TM 11-6625-274-35

TEST SETS, ELECTRON TUBE TV-7/U,
TV-7A/U, TV-7B/U, AND TV-7D/U

CHANGE }
No. 5 }

CHANGE }
No. 4 }

Figure 44(2). Test Set, Electron Tube TV-7D, schematic diagram (sheet 2).

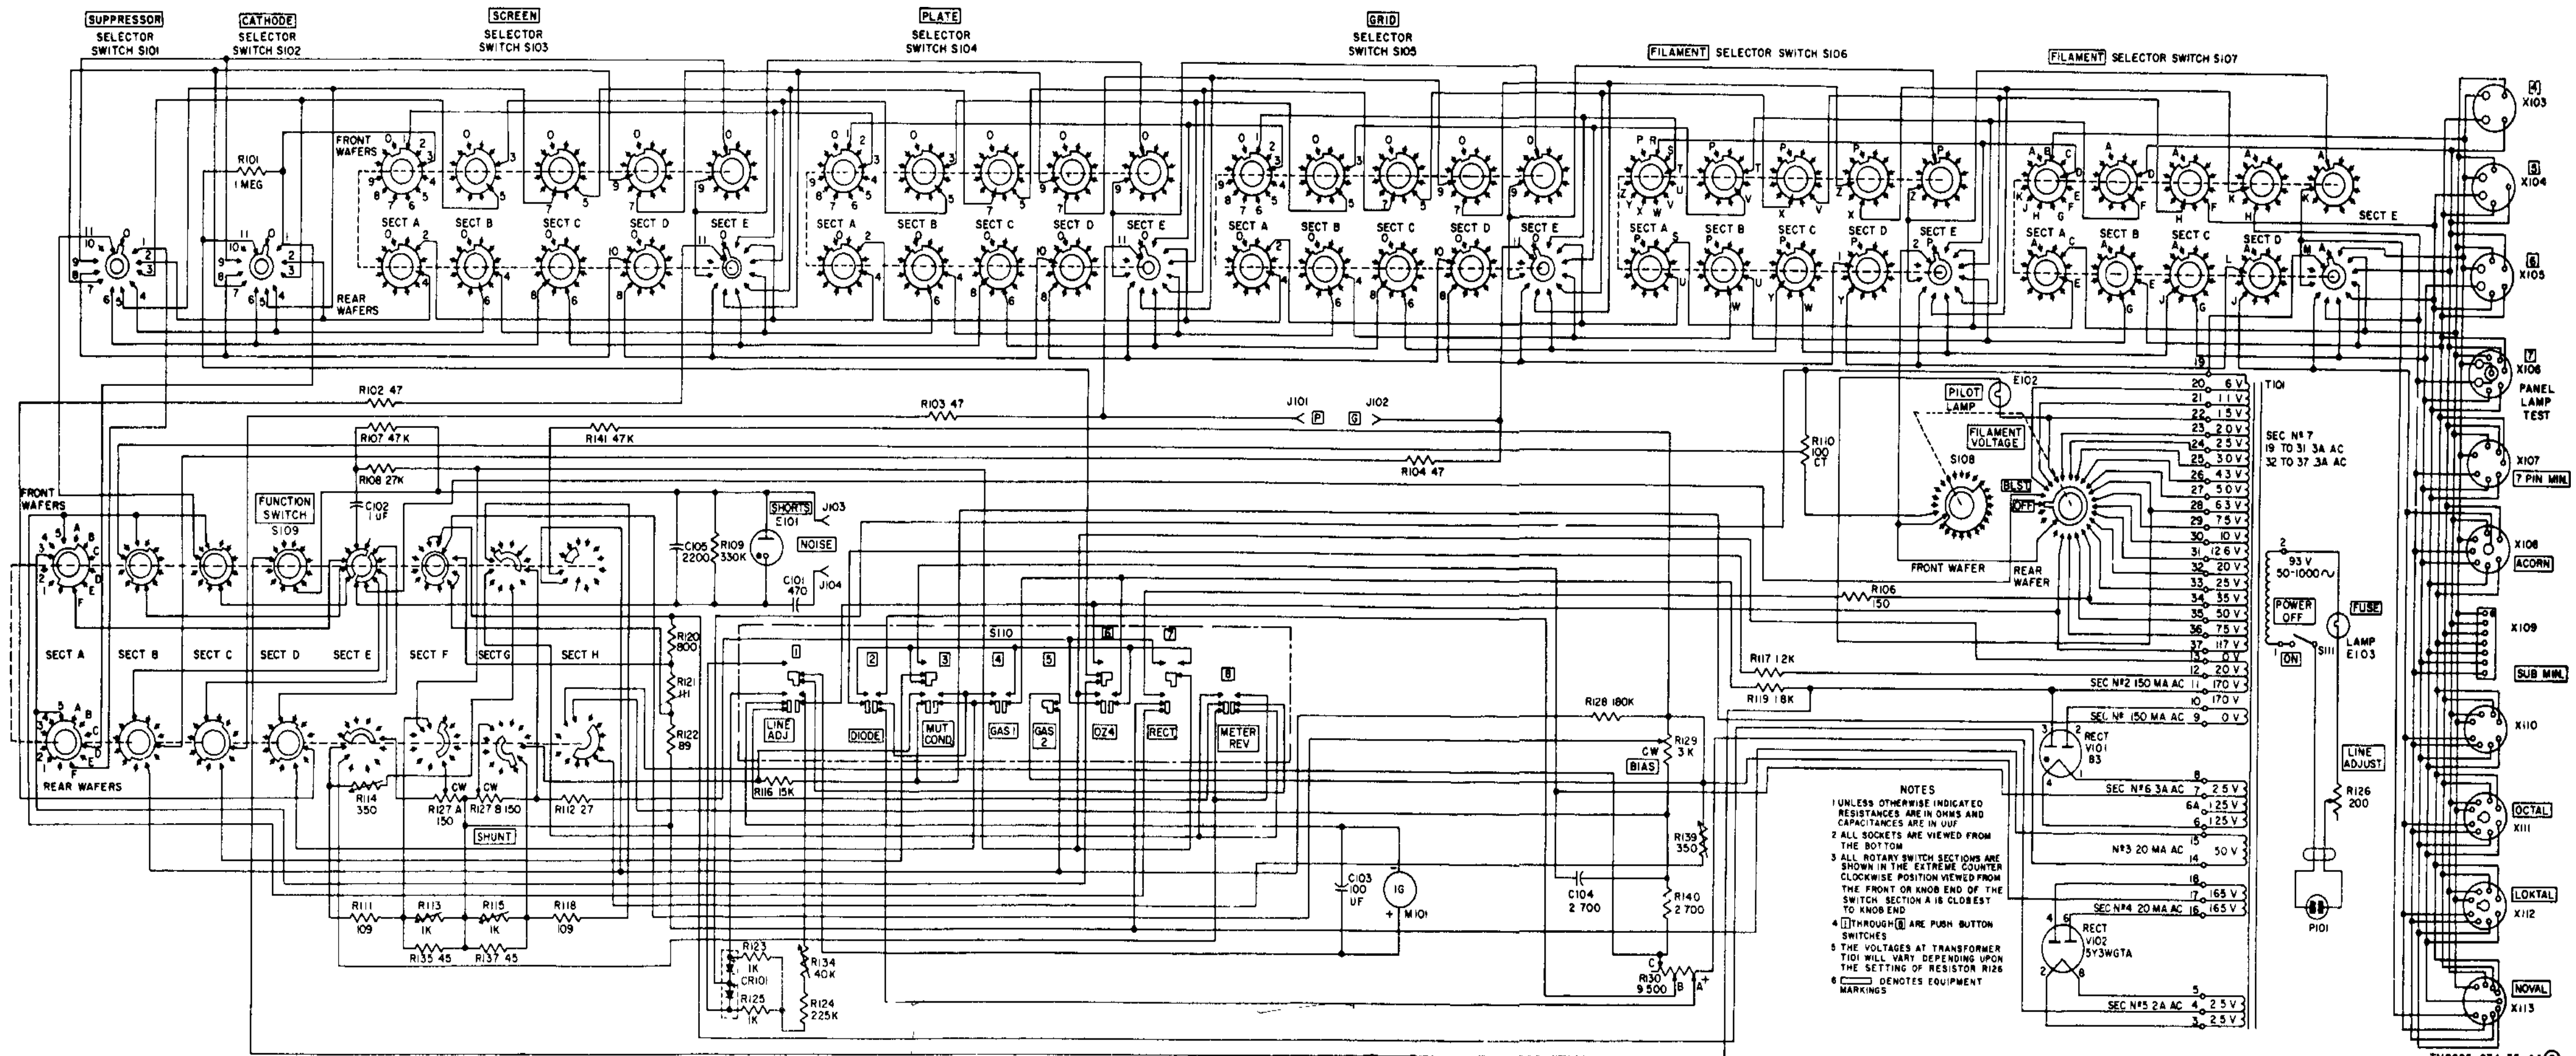
Figure 44② (sheet 2), switch S109, section F. Delete the connection between contacts D and E and substitute 2 connections between C and E.
